## **2nd Gen Indoor Station Firmware V2.1.34\_build211118 Release Note (2021-11-22)**

Device Model	DS-KH8350-WTE1、DS-KH8350-TE1、DS-KH6320-WTE1、DS-KH6320-WTE2、DS-KH6320-WTE2(B)、DS-KH6320-TE1、DS-KH8520-WTE1
Firmware Version	V2.1.34_build211118
iVMS-4200 Version	Latest version
Hik-Connect APP	Latest version

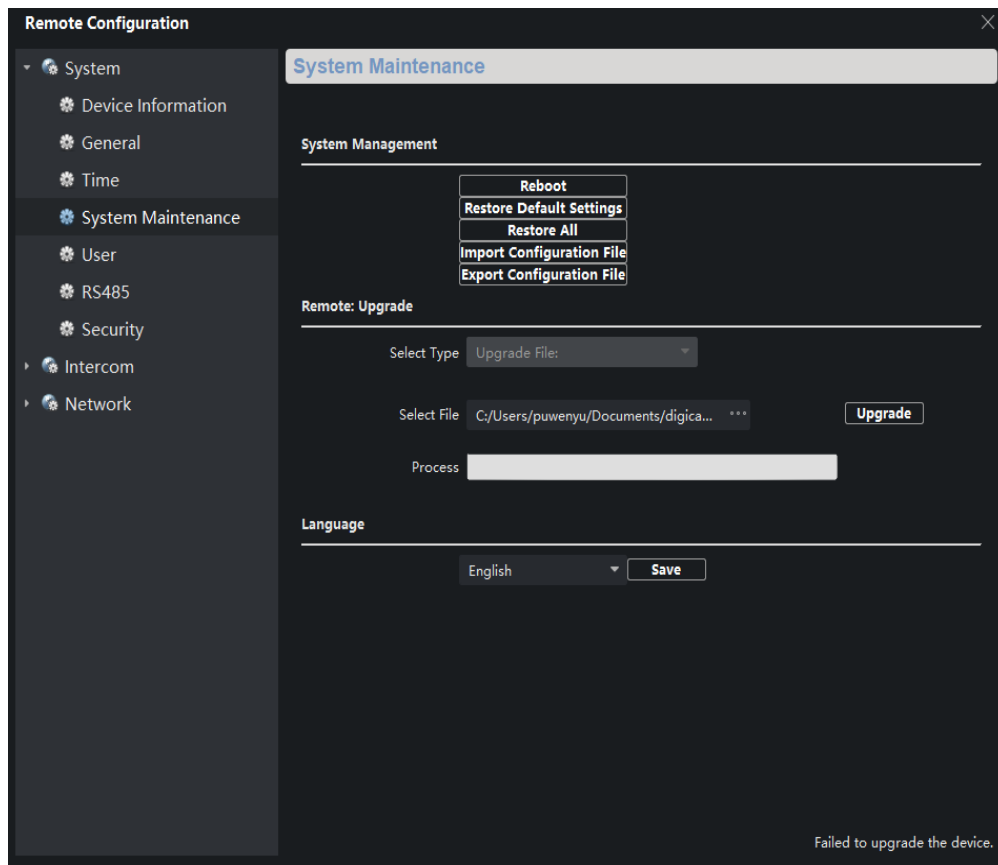
2. Hik-Connect Service Settings is changed to the place of Settings→ Advanced Settings→ Configuration→ System Maintenance.

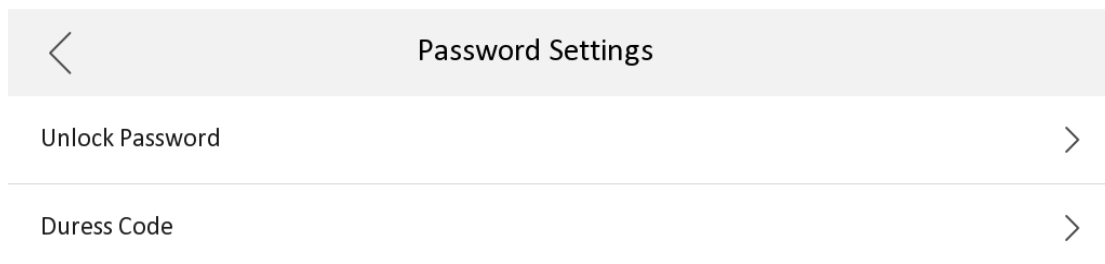
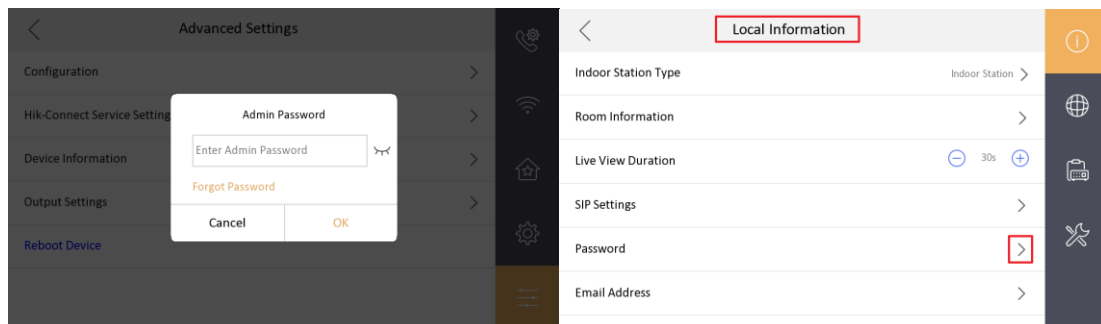
3. Newly added multi-language Croatian, Dutch, Romanian, Czech, Bulgarian, Croatian, Serbian
4. Add IPC interface, when Open Network Video Intercom protocol is selected, add plaintext ciphertext switch menu item configuration

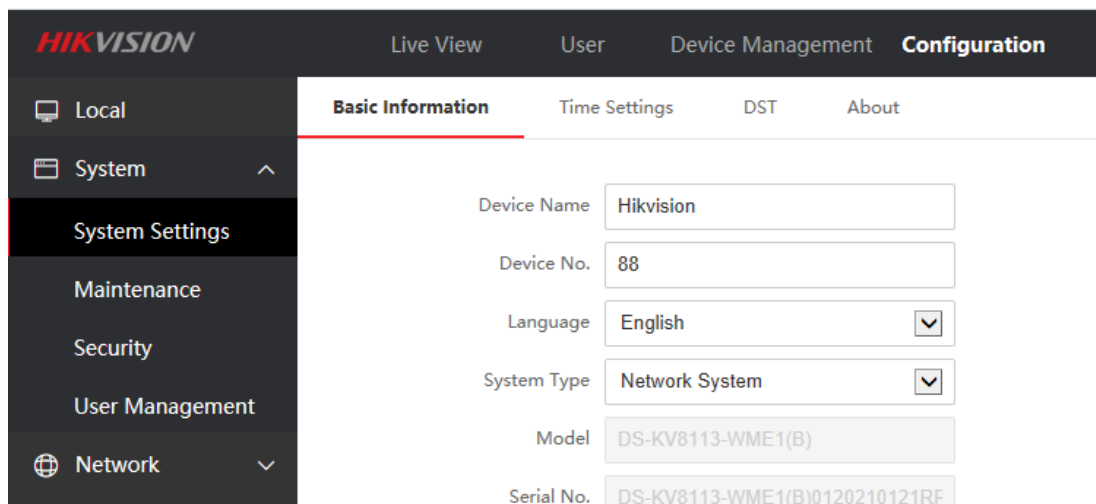
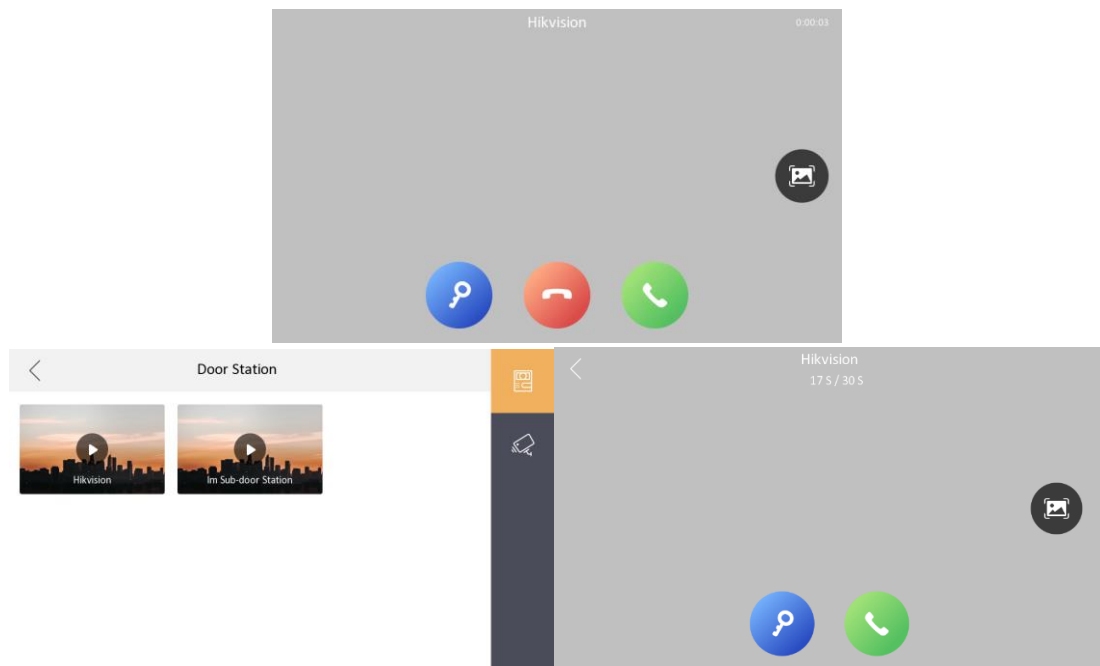
1. Change the position of unlock password and duress code, to enter the password page requires an admin (activation) password.

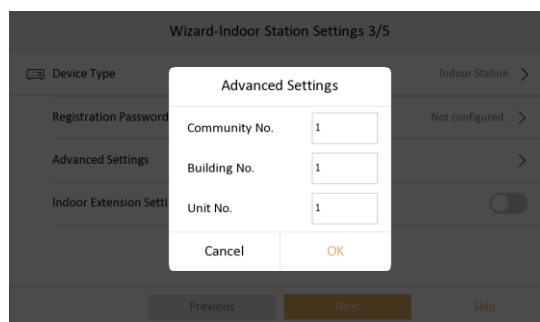
2. When changing the unlock password and duress code, the old password is not required as a credential.
3. The name of the local private SIP password configuration Sip Password is uniformly changed to Registration Password
4. The changed name of the door station(KD8003 modular door station, KV(-B), KB8113) will be displayed on the call interface or live view interface of the indoor station

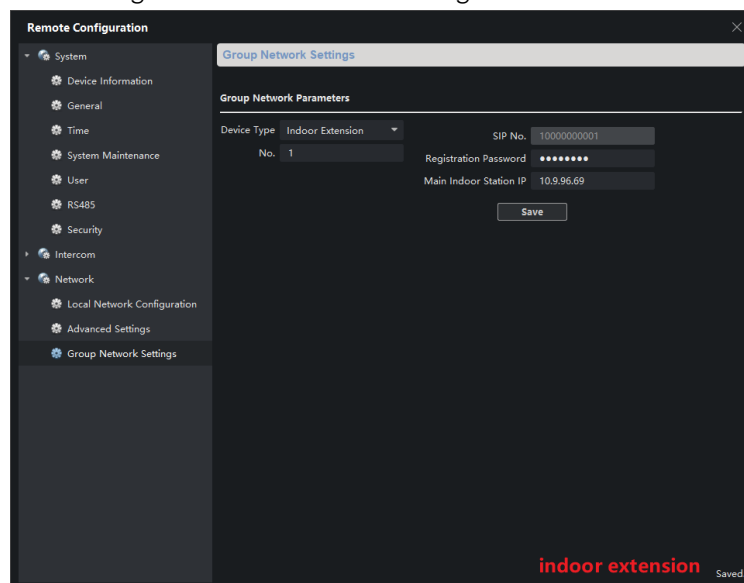
5. The local interface community number, building number, and unit number of the indoor station will be stored in the advance column instead of being displayed directly

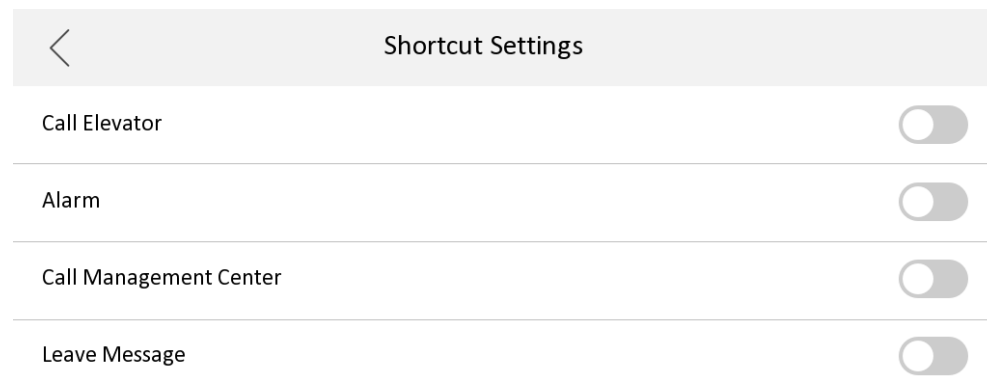
4. The indoor station supports remote scene switching through Hik-Connect, including four modes: Stay, Away, Sleeping and Custom.

When the indoor station is not currently configured with the arm/disarm password, the Hik-Connect switching scene will fail, and indoor station will send an error code to Hik-Connect App

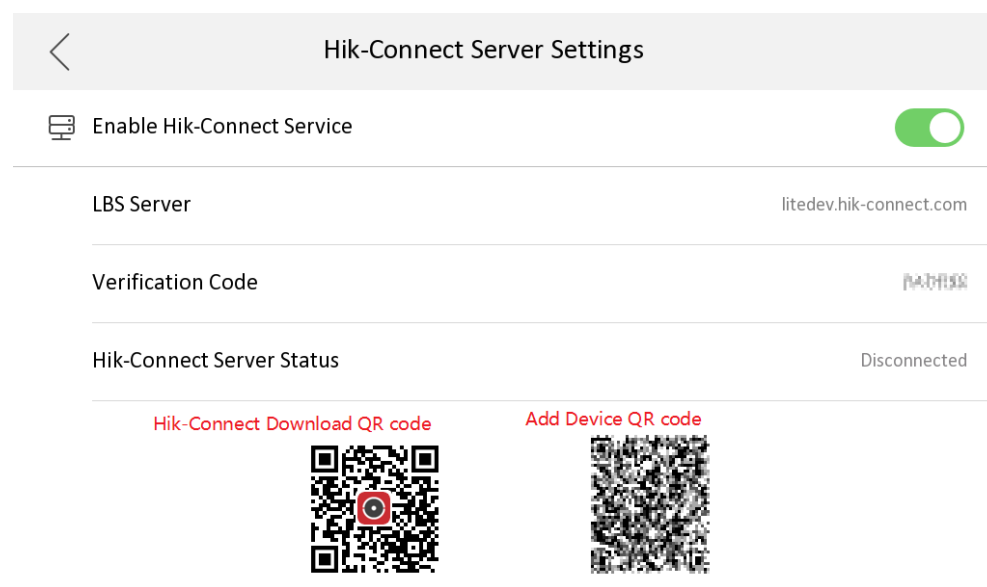
6. Support whether to enable the leave message function, it is disabled by default

1) In the Settings->More->Preference->Shortcut Settings interface

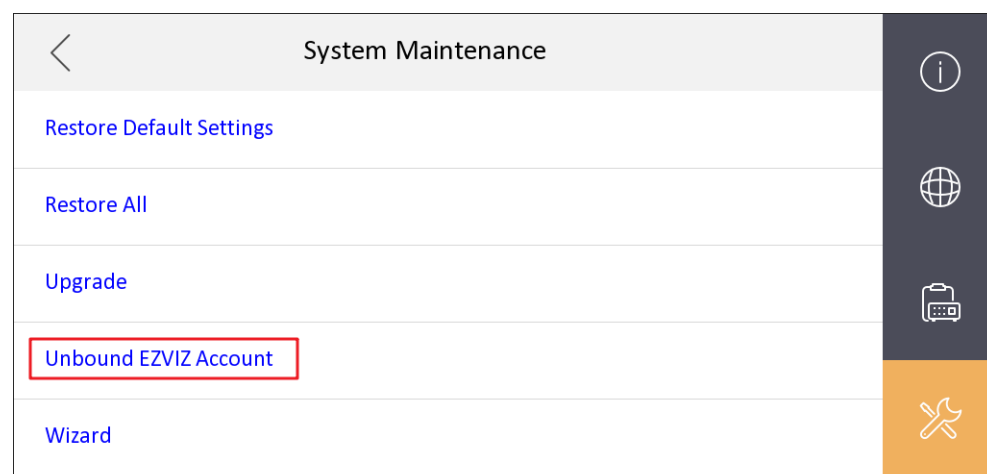
7. Add the QR code of Hik-Connect App download address to the indoor station Hik-Connect configuration interface

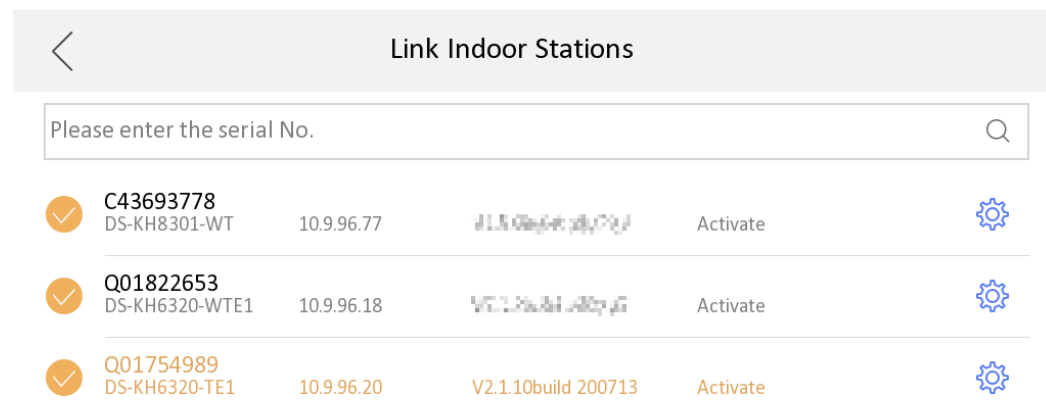
1) Support setting period number, building number, unit number, and room number on the indoor station;

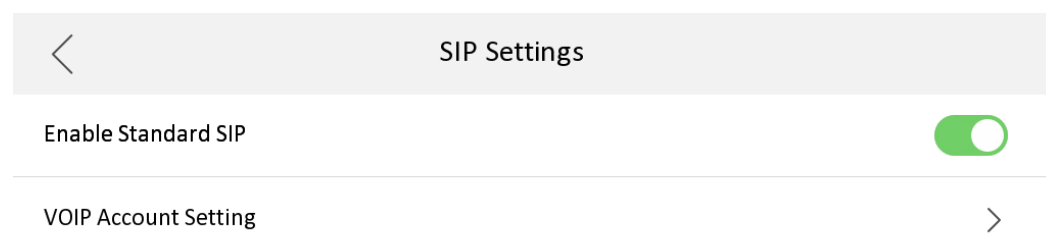
2) Support remote configuration of indoor extension information through the main indoor station;

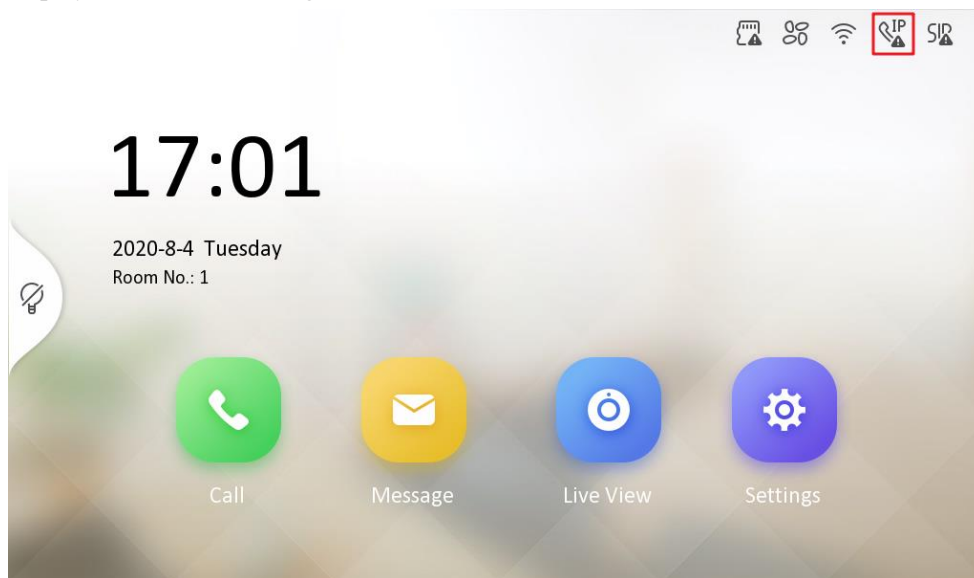
b) The standard SIP of the indoor station is disabled by default, if you want to connect to a third-party standard SIP device, you need to turn on this function.

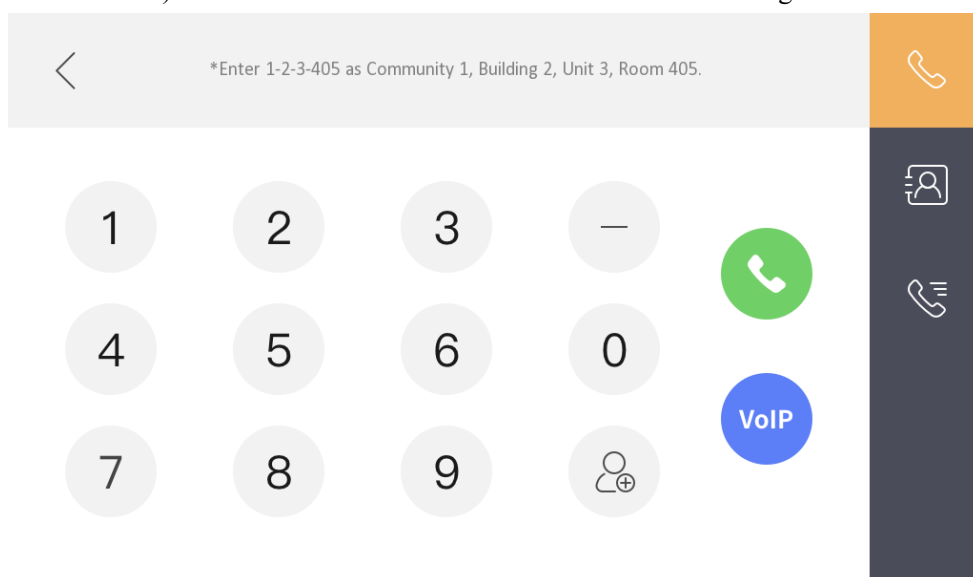
c) A standard SIP registration status icon is added to the main interface, which can be displayed/hidden according to whether standard SIP is enabled;
